**FINAL DRAINAGE REPORT  
FOR  
LATIGO TRAILS FILING NO. 9  
AND  
ADDENDUM TO MASTER DEVELOPMENT/  
PRELIMINARY DRAINAGE PLAN  
FOR LATIGO TRAILS,  
EL PASO COUNTY, COLORADO**

June 2022

PCD File No.: SF2136

LATIGO TRAILS FILING NO. 9  
DRIVEWAY CULVERT EXHIBIT  
JOB NO. 2517502  
6/14/2022  
SHEET 1 OF 1

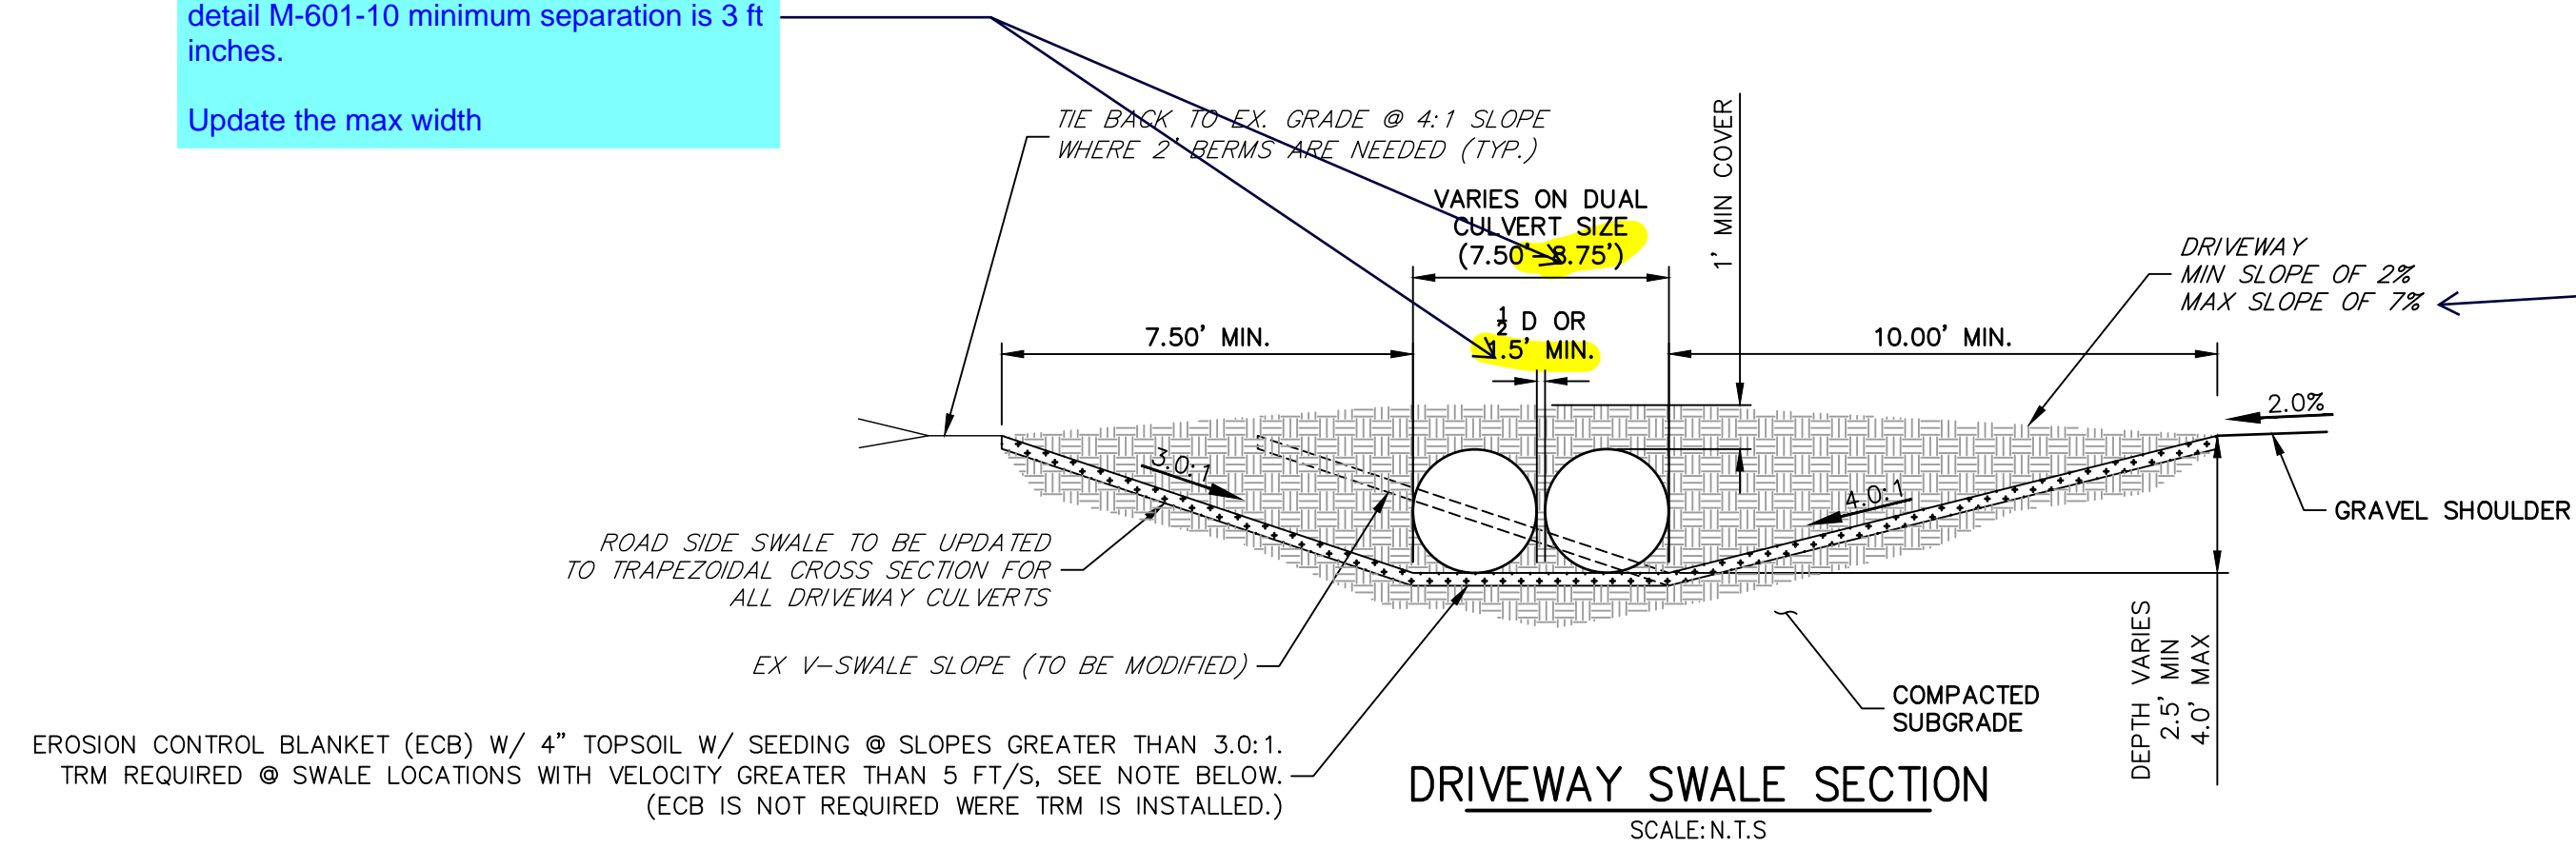
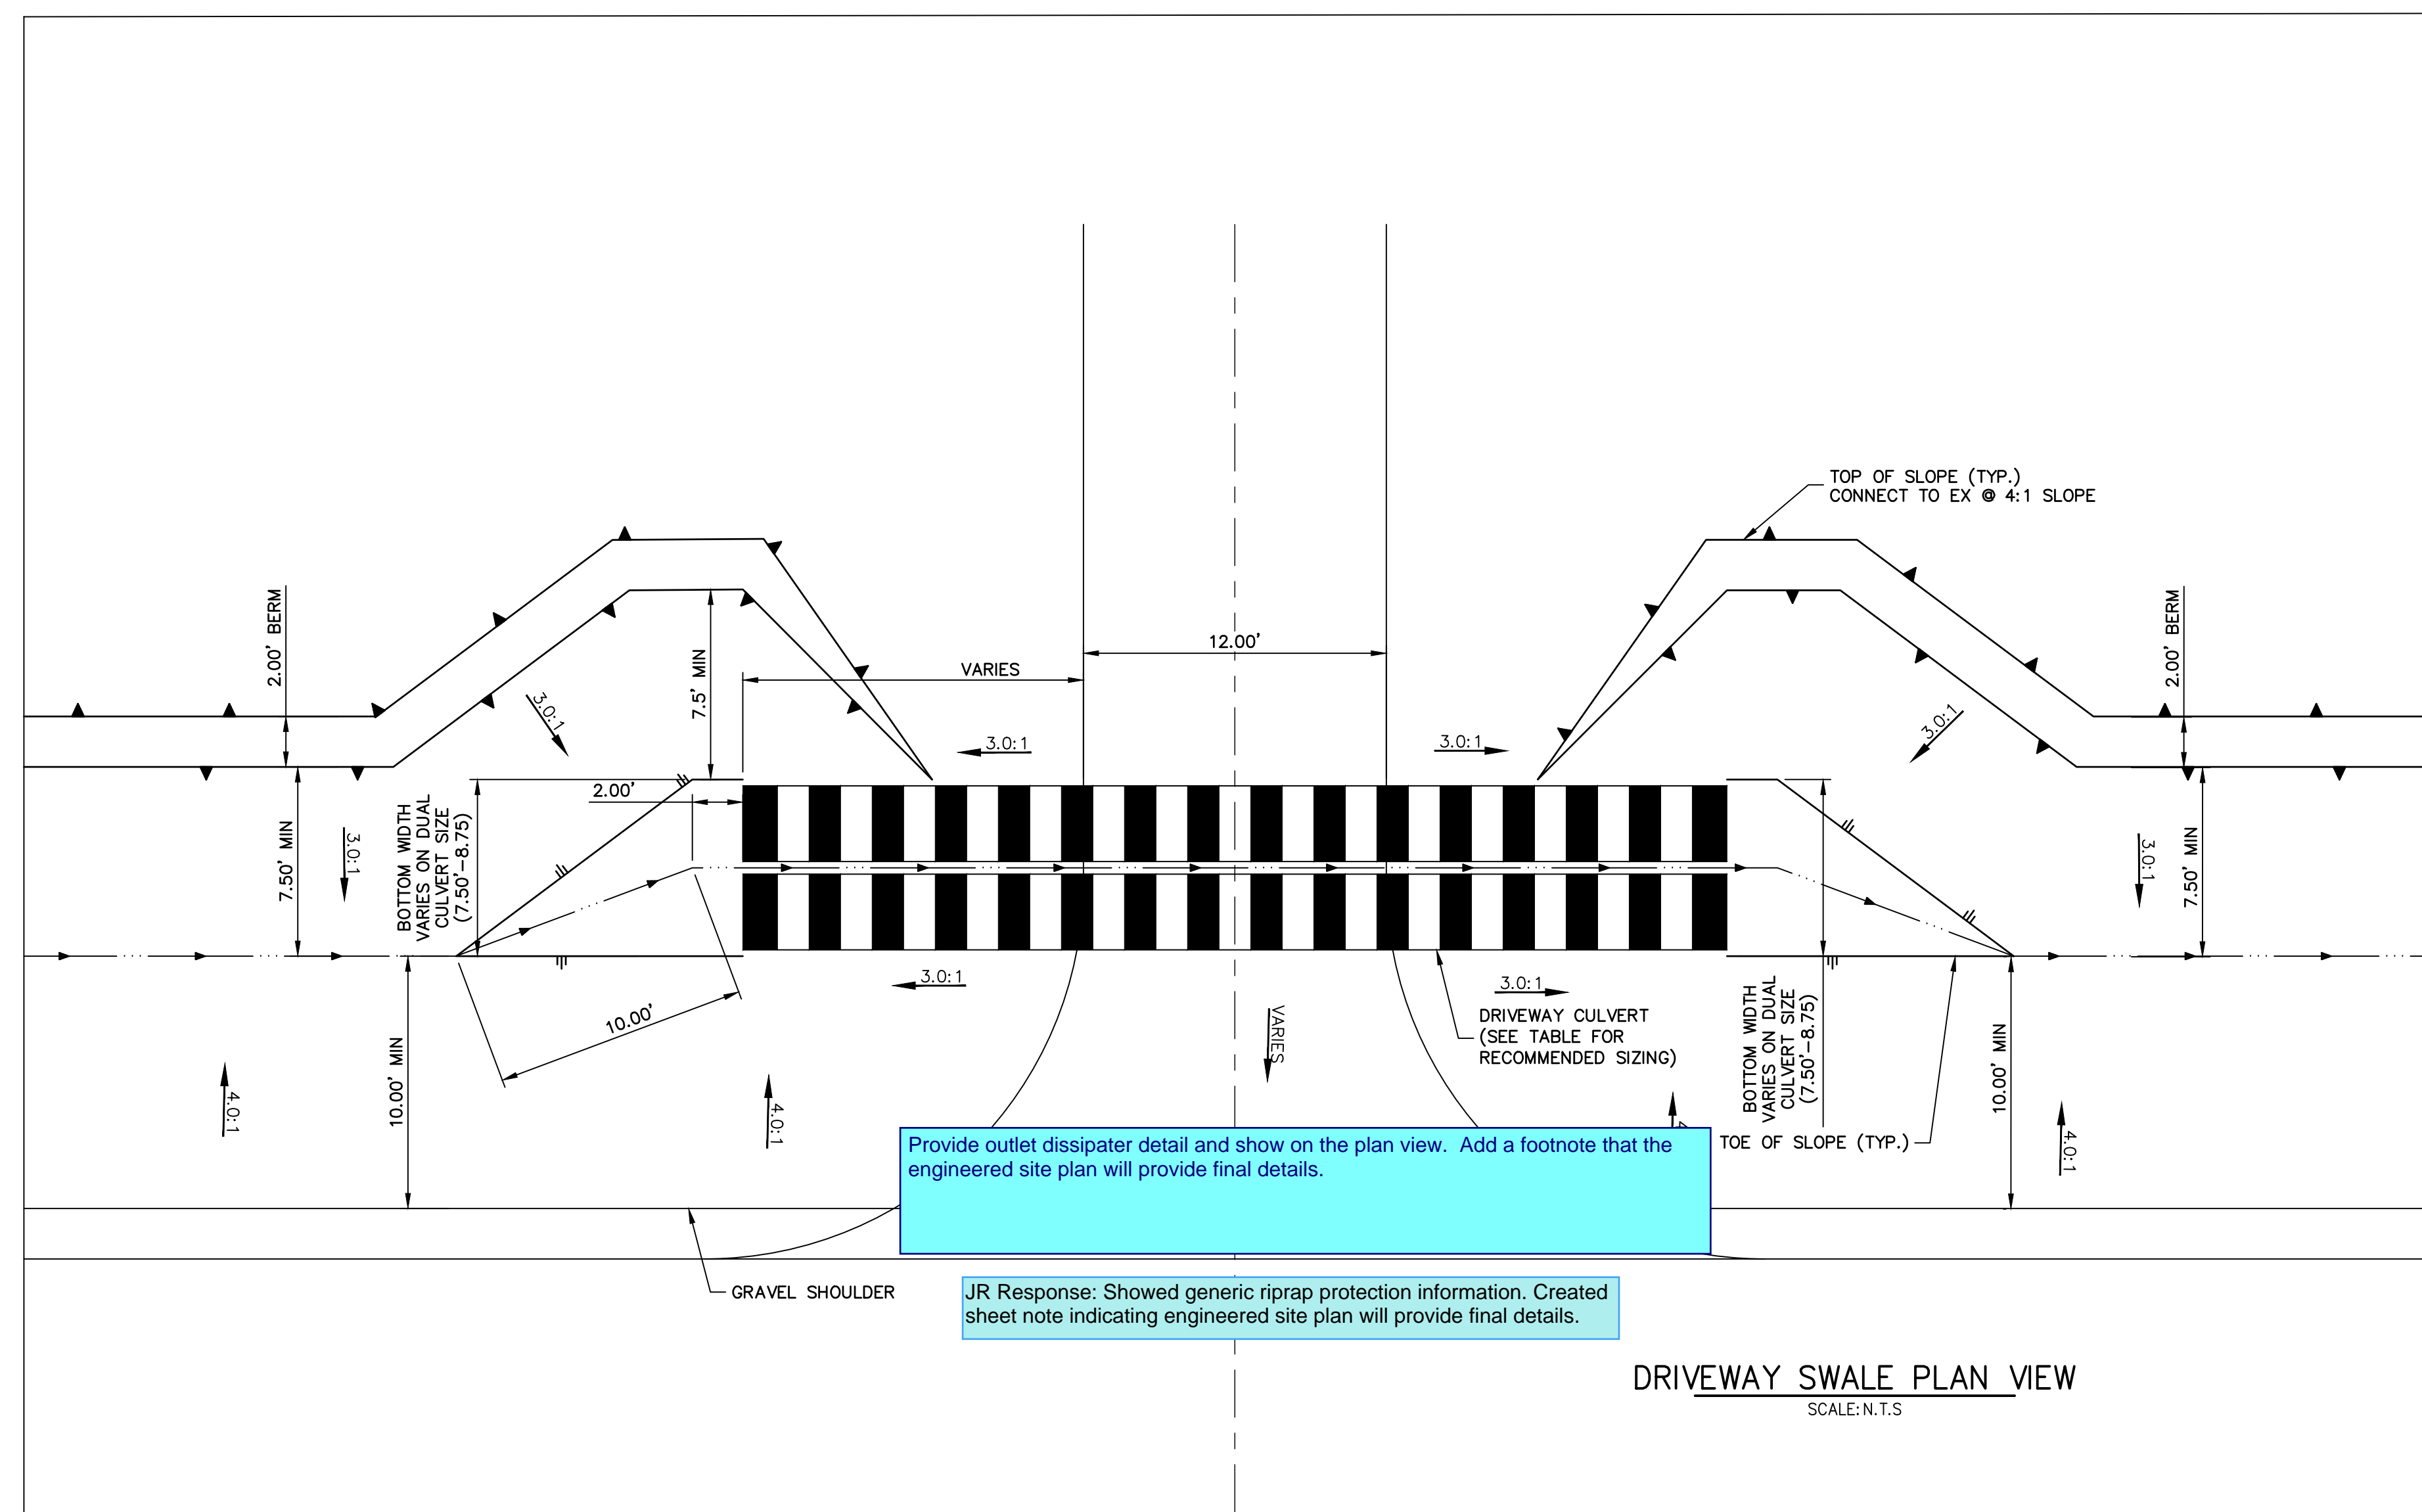
Revise to 4% Max slope for a minimum 20 feet  
from edge of roadway per ECM Appendix F detail  
SD\_3-14

Check to make sure the drainage easement along these lots have the appropriate width for the wider roadside ditch.

Show the typical ROW and drainage easement location on both the plan view and profile view

Provide outlet dissipater detail and show on the plan view. Add a footnote that the engineered site plan will provide final details.

JR Response: No headwall is proposed. Also per that detail the minimum separation can be smaller, depending on the diameter of the pipes.  
Created profile view for more detail.

JR Response: Revised max slope.

JR Response: Attached HY-8 reports for future driveway culverts. Included one report per size using the maximum flow for that size.

JR Response: Used the largest instance for the plan and profile view. Also added in the R.O.W. and drainage esmt. linework to show limits.

JR Response: Revised to show both in plan and profile view.

JR Response: Showed generic riprap protection information. Created sheet note indicating engineered site plan will provide final details.
